JOB NAME: ARACO Concrete

COPIES	DESCRIPTION	REMARKS
1	Traffic Impact Study	Combined into one PDF document
1	Deviation	
1	Responses to TIS Comments	
1	Responses to AutoTurn Comments

ARACO Concrete
Transportation Memorandum
(LSC #194560)
PCD File No.: PPR1950
March 26, 2021

RE: ARACO Concrete
El Paso County, CO
Transportation Memorandum
LSC # 194560
PCD File No. PPR1950

AutoTurn Figure 1
Exiting
AutoTurn Analysis
 Araco (LSC #194560)

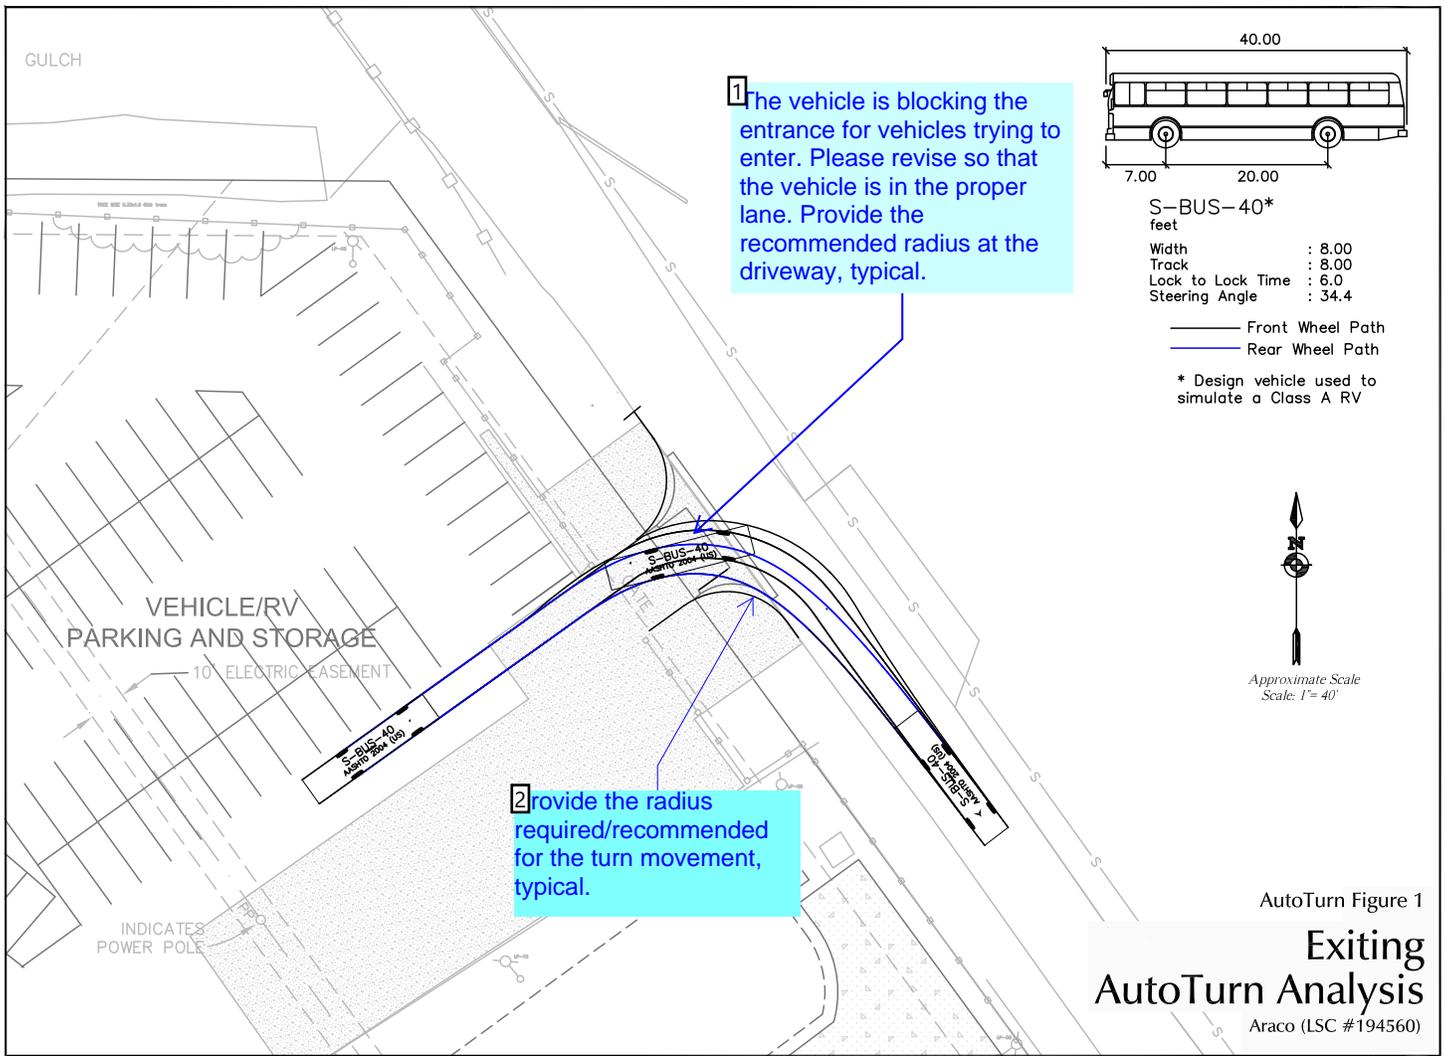
1 The vehicle is blocking the entrance for vehicles trying to enter. Please revise so that the vehicle is in the proper lane. Provide the recommended radius at the driveway, typical.

2 Provide the radius required/recommended for the turn movement, typical.

The vehicle is blocking the entrance for vehicles trying to enter. Please revise so that the vehicle is in the proper lane. Provide the recommended radius at the driveway, typical.

LSC Response: The site plan has been revised and the AutoTurn rerun with the updated radius.

AutoTurn Figure 1
Exiting
AutoTurn Analysis
 Araco (LSC #194560)

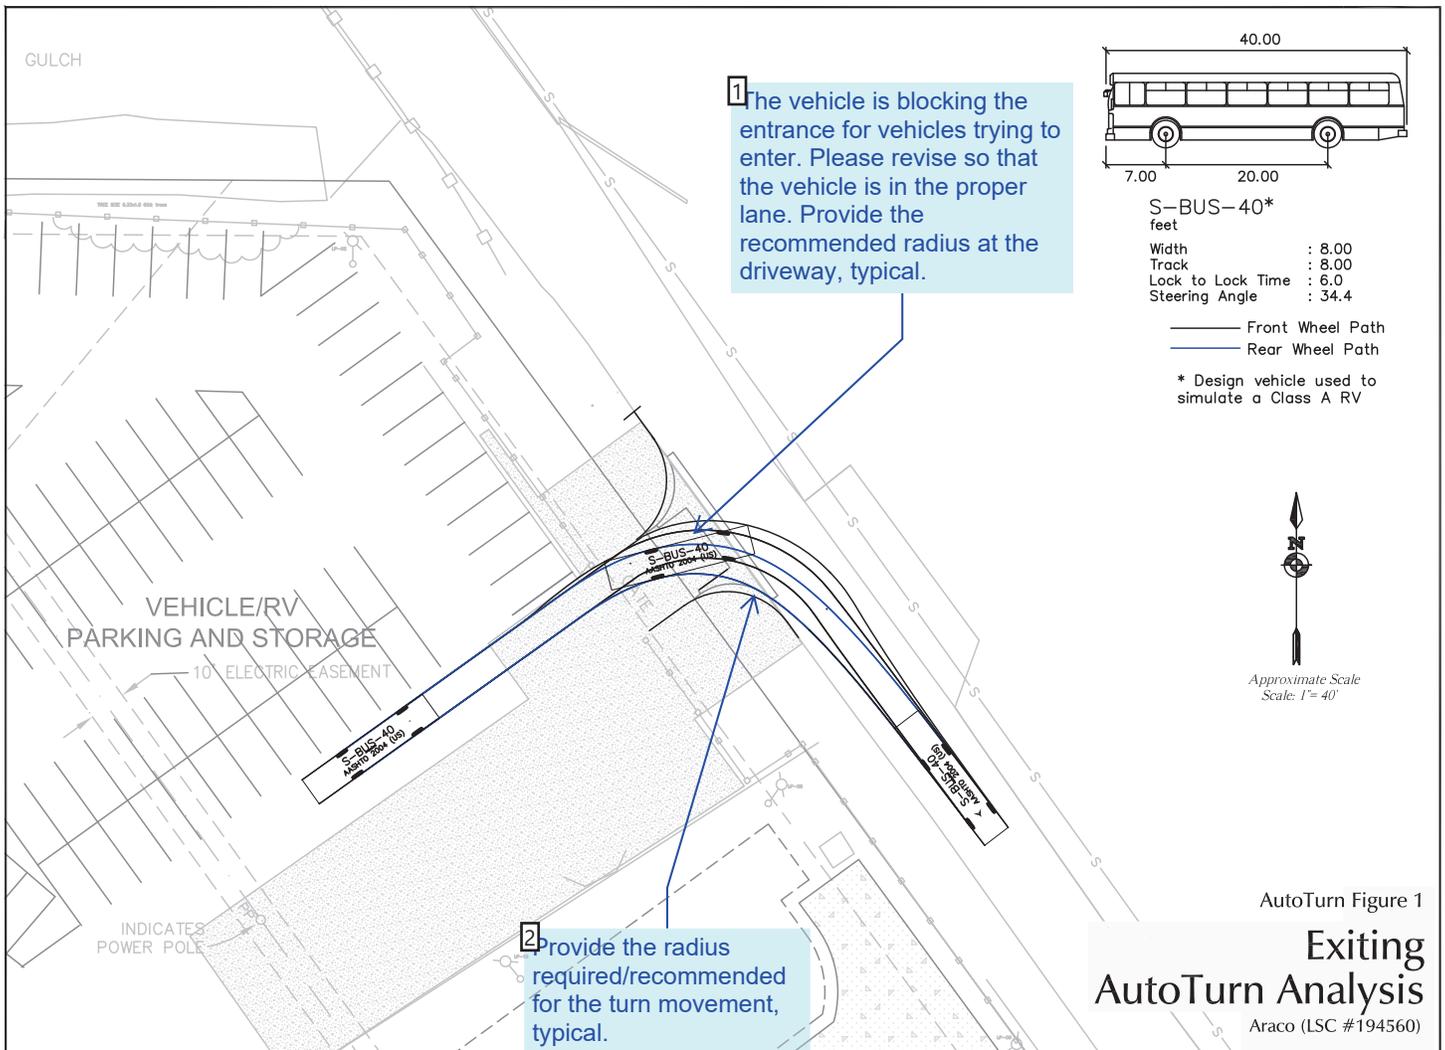
Provide the radius required/recommended for the turn movement, typical.

The vehicle is blocking the entrance for vehicles trying to enter. Please revise so that the vehicle is in the proper lane. Provide the recommended radius at the driveway, typical.

Provide the radius required/recommended for the turn movement, typical.

LSC Response: The site plan has been revised and the AutoTurn rerun with the updated radius.

LSC Response: The site plan has been revised and the AutoTurn rerun with the updated radius.

LSC Response: The site plan has been revised and the AutoTurn rerun with the updated radius.
